ALERT SERVICE BULLETIN

UH-1H-II-22-32

MODEL AFFECTED: UH-1H-II

SUBJECT: MAIN ROTOR SCISSORS & SLEEVE HUB ASSEMBLY 204-011-405-013 IDENTIFICATION

Figure 1 – Hub Assembly Ink-Stamped Part Number and Serial Number

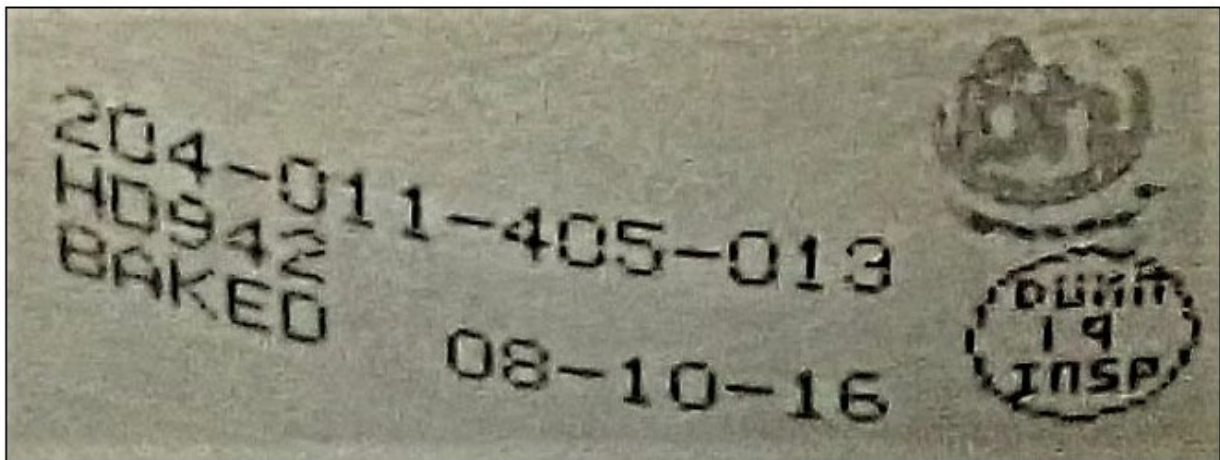
2. Confirm if there is a Historical Service Record (HSR) for the Hub Assembly (204-011-405-013) and that it contains the serial and part numbers.
3. Gain access to the Hub Assembly 204-011-405-013 and inspect for the presence of part number and serial number matching the Historical Service Record (HSR) at the location shown on Figure 1.

4. If the Hub Assembly is not correctly marked, as shown in Figure 1, proceed with **PART II**.
5. If the Hub Assembly is correctly marked, as shown in Figure 2, make an entry in the helicopter logbook and historical service records indicating findings and compliance with **Part I** of this Alert Service Bulletin .

2. If the Hub Assembly has an ink-stamped part and serial number matching the HSR (refer to example shown in Figure 1), permanently mark the part and serial number on the Hub Assembly by vibro-etching or dot-peening (Figure 2).
3. If the Hub Assembly does not have a part number and serial number, create a unique serial number for each Hub Assembly. Using one or two prefix letters consistent with the company name of the operator or repair facility accompanied by a dash and 4 or 5 digits is considered as an industry serial number marking standard. Vibro-etch or

Maximum depth of vibro-etching or dot-peening shall not exceed 0.005-inch (.127 mm). Part and serial numbers shall be marked in the scalloped area of the hub as shown in Figure 2 of this ASB; to a minimum height of 0.062-inch (1.57 mm) and no closer than 0.100-inch (2.54 mm) to any edge

dot-peen the Hub Assy with the part number and the assigned serial number (Figure 2). For example, Papa Tango Aviation Inc. could use “204-011-405-013 / PT-01234”.

4. After marking the part and serial number identification, apply brush cadmium plating solution (C-108) to the affected area (BHT-ALL-SPM). As an alternate and if brush cadmium plating isn't available, apply two coats of polyamide epoxy primer (C-204).
5. If no Historical Service Record exists for the Hub Assy, create one as follows:
 - a. Print a blank form from www.bellhelicopter.net under the “GENERAL INFO” tab.
 - b. Enter the Hub Assembly part number and the serial number created above.
 - c. Add the following note beside the serial number: “Serial number created as per ASB UH-1H-II-22-32.
 - d. Enter the actual flight hours or the flight hour value calculated.
 - e. Ensure the Hub Assembly information is entered on the HSR.
6. The Hub Assembly 204-011-405-013 is a life-limited item that should have been tracked by the operator even if the part was not correctly identified.
